**BULLETIN NUMBER:**  
CB26-E-001

#### FVR FRONT STABILIZER BAR

**SAFETY RECALL (NEW UNSOLD DEALER INVENTORY ONLY) -- 25V-719**

Figure 1

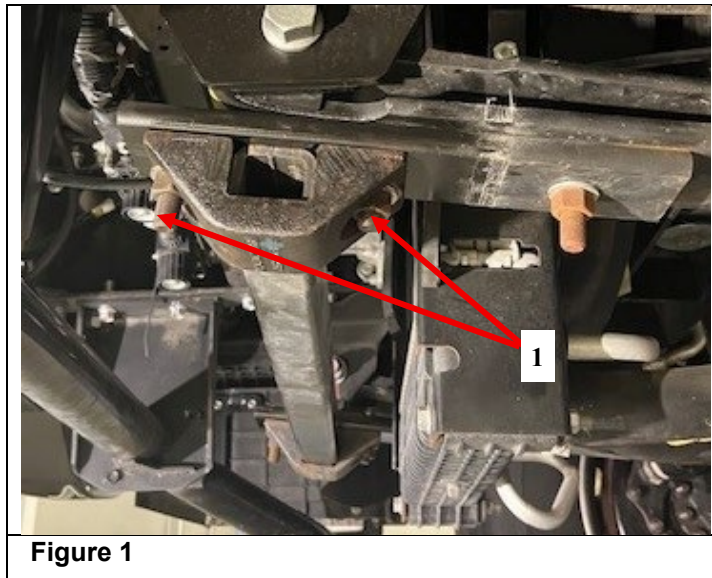
1. Spray a small amount of penetrating oil onto the stabilizer bar bracket mounting studs. This will help reduce possible damage to the mounting studs and nuts during this procedure.
2. Using a deep well socket, remove the two driver's side nuts and washers (1) from the stabilizer bar bracket. (See Figure 1.)

**NOTE: An 18mm wrench can be used to hold the stud in place if the stud spins while loosening the nuts.**

Figure 2

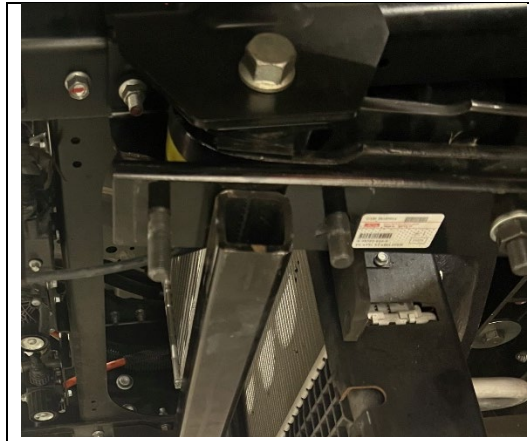
3. Remove the driver's side stabilizer bar bracket. (See Figure 2.)

**NOTE: The stabilizer bar bracket may have to be loosened to remove it by carefully tapping it with a hammer.**

Figure 3

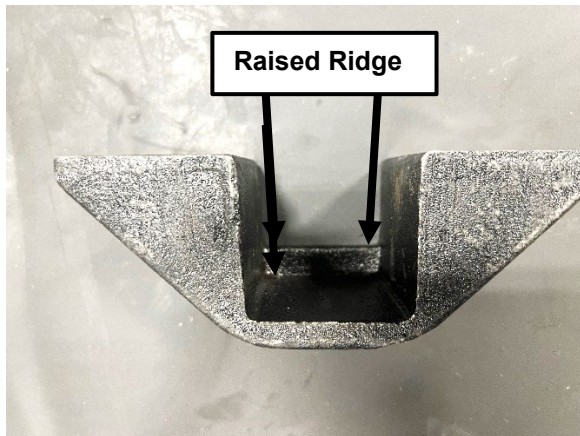
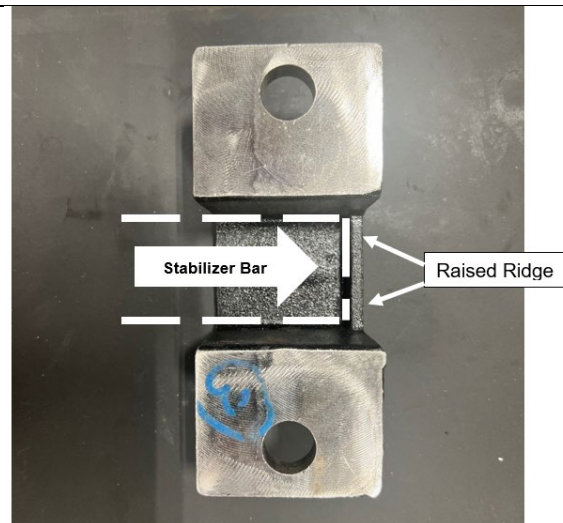
4. Install a *new* stabilizer bar bracket onto the driver's side using the original washers and nuts.

**NOTE:** Install the bracket so that the raised ridge is outside the end of the stabilizer bar. (See Figures 3 and 4.)
